# ADDENDUM NO. 2

**August 31, 2023**

## **New Buffalo Elementary Kitchen Renovation & Addition**

This Addendum consists of pages ADD 2-1 through ADD 2-2 Specification Sections 00 20 00 Information Available To Bidders, 01 32 00c Schedules and Reports, and 01 12 00 Multiple Contract Summary, and attached TowerPinkster Addendum No. 2 dated August 30, 2023, consisting of 1 page, Specification Section 10 4413 Fire Protection Cabinets, revised Specification Sections 08 3313 Coiling Counter Door and 10 2800 Toilet, Bath, and Laundry Accessories, and revised drawing sheets: G 001, A 101, A 501, ED 101, E 101, E 301, E 302, L 103, L 104.

**FIRST FLOOR DEMOLITION PLAN**  
1/8" = 1'-0"

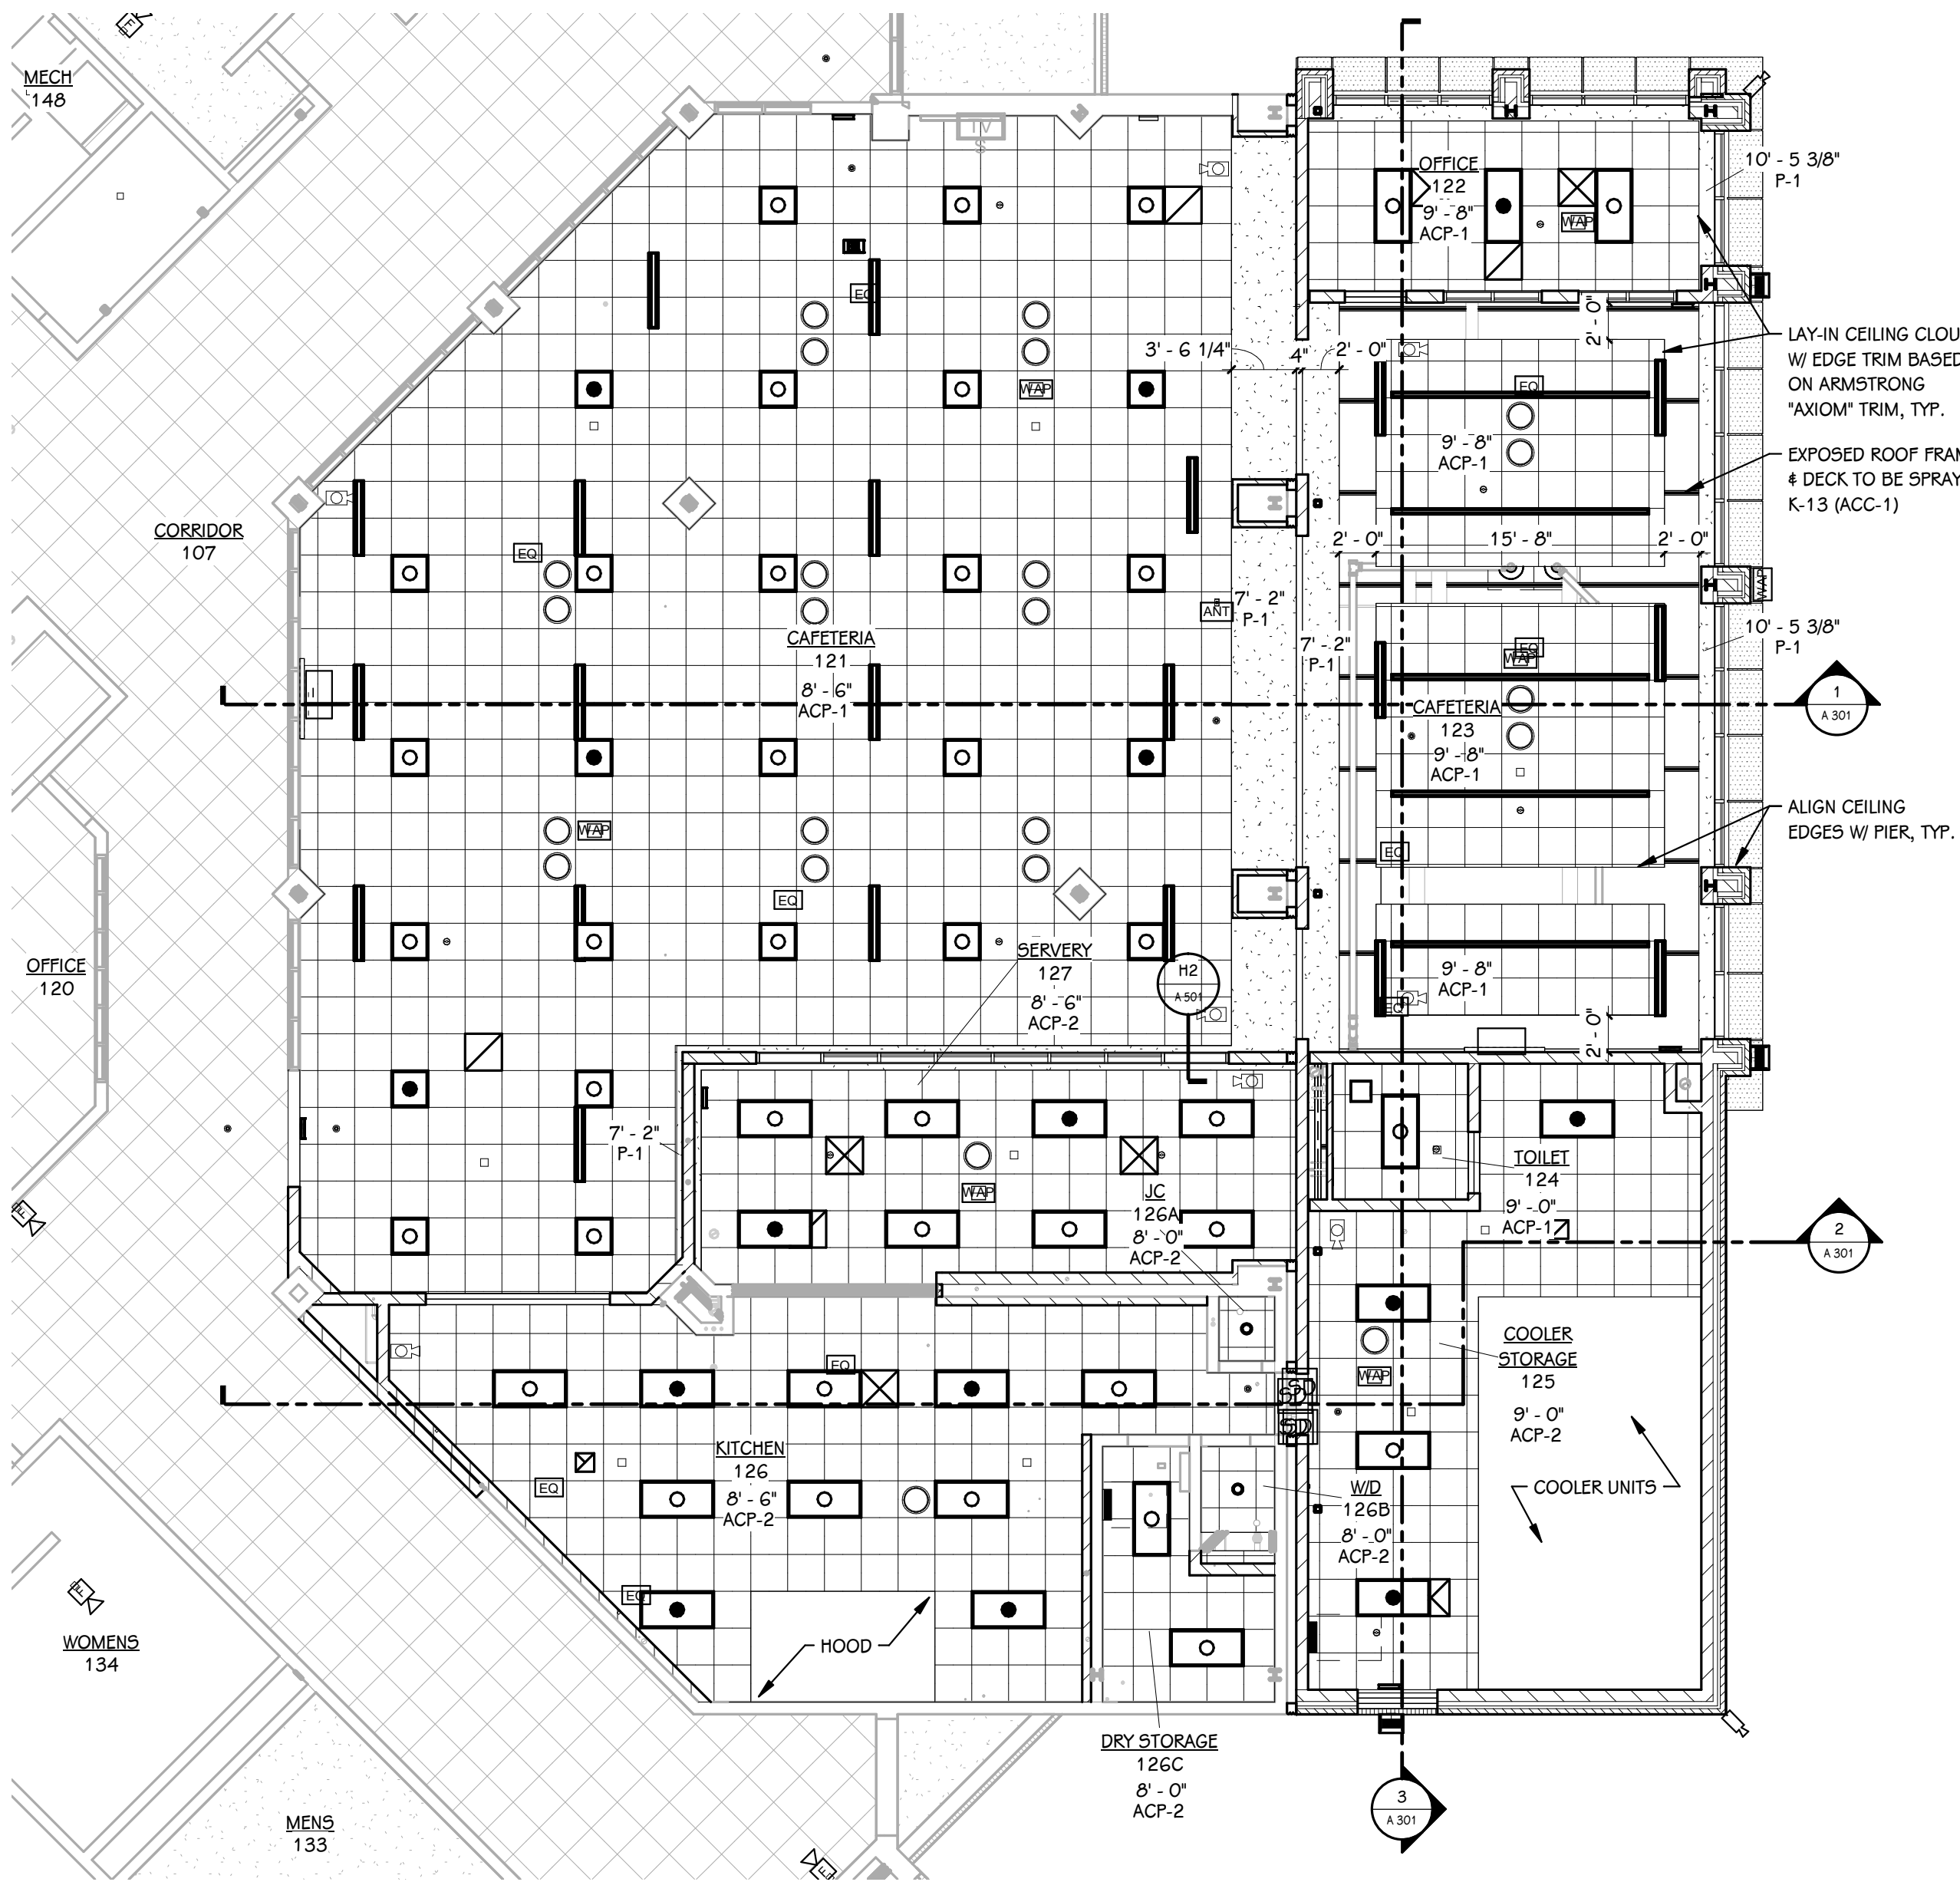
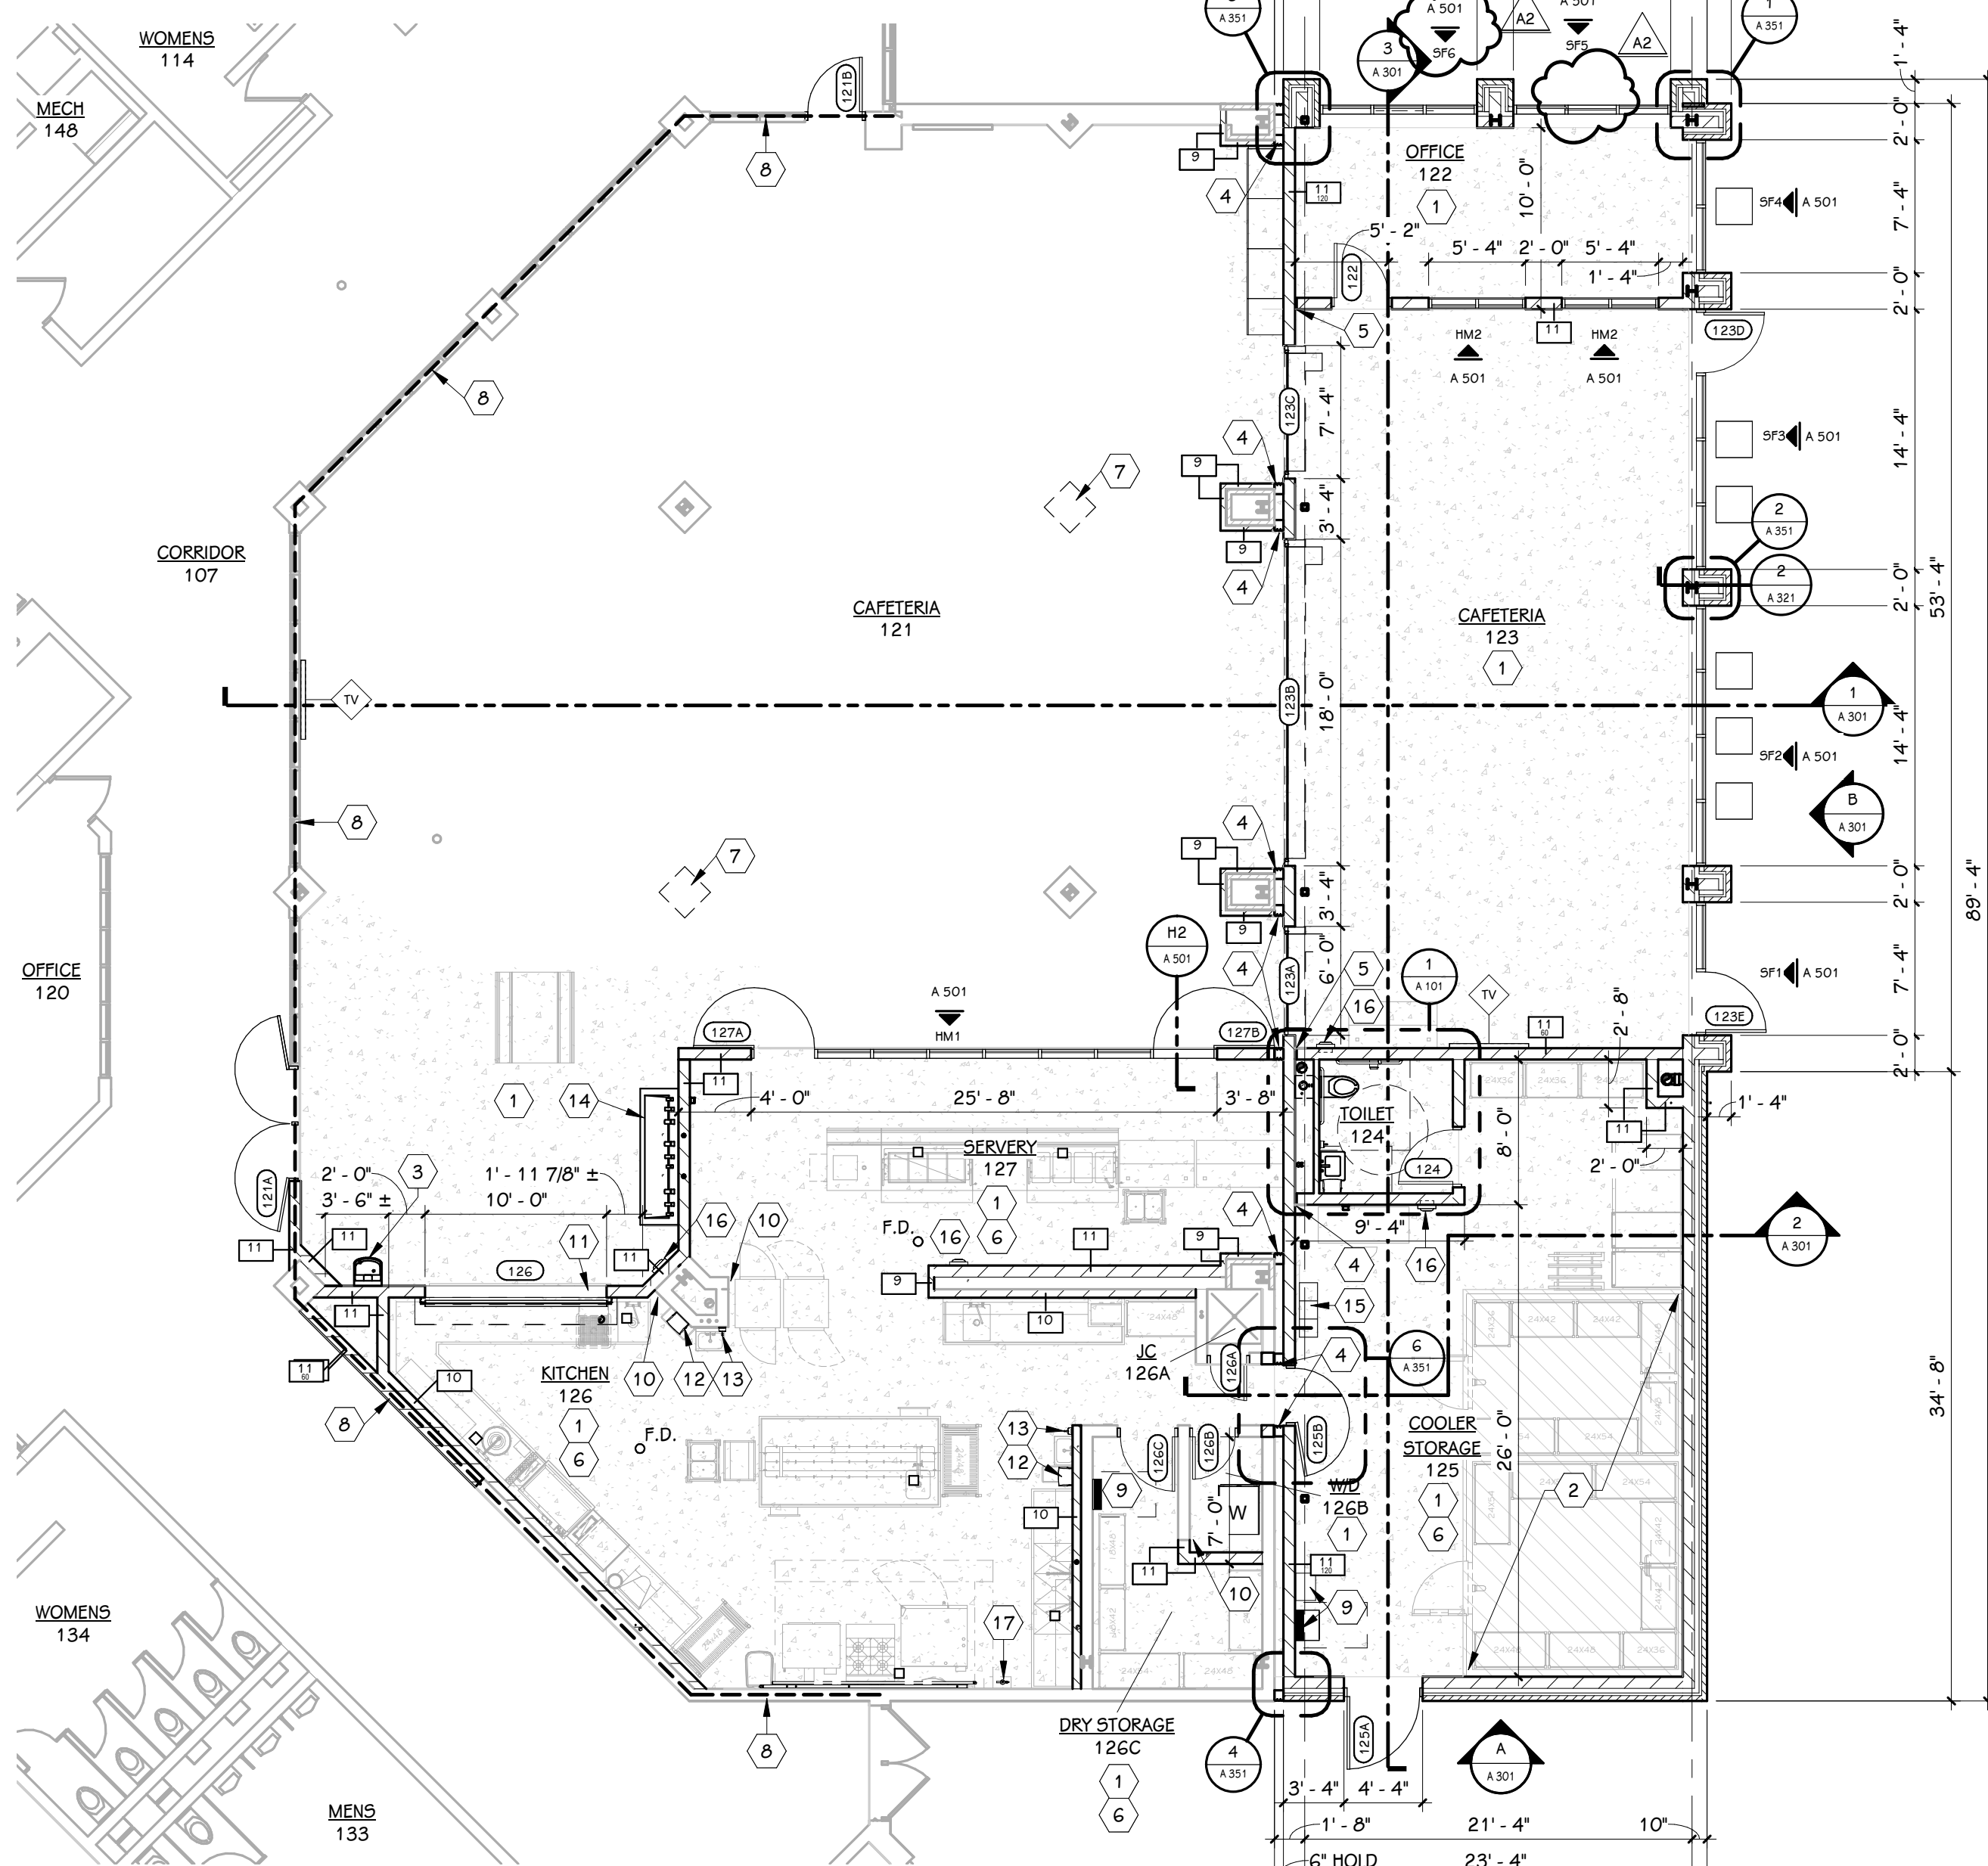
**ADD-2 Item No. D-1 - Sliding Window Clarification**

Refer to Sheet(s): A 101, A 501

Clarification from RFI 003. Updated sliding window location.

SHEET TITLE  
DOOR SCHEDULE & DOOR REVIEW  
PLAN

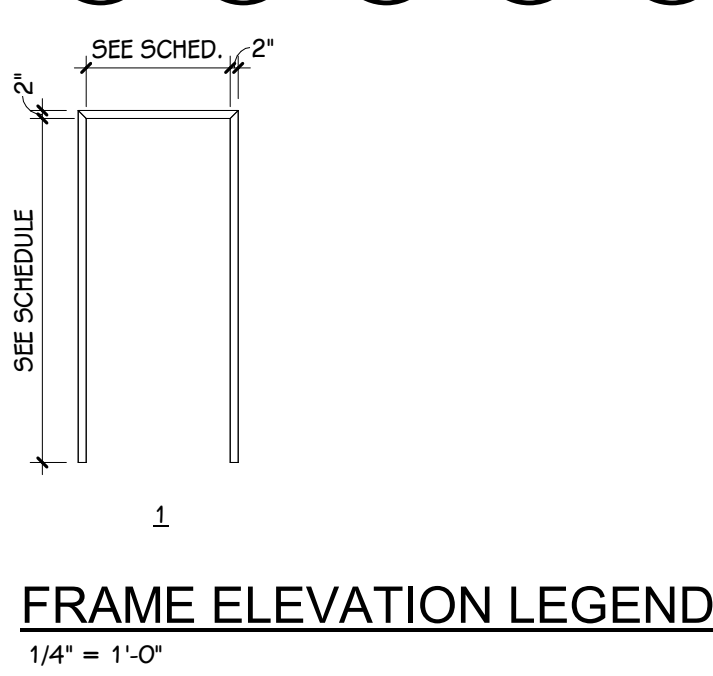
**ADD-2 Item No. D-2 - Door Schedule**

Refer to Sheet(s): A 501
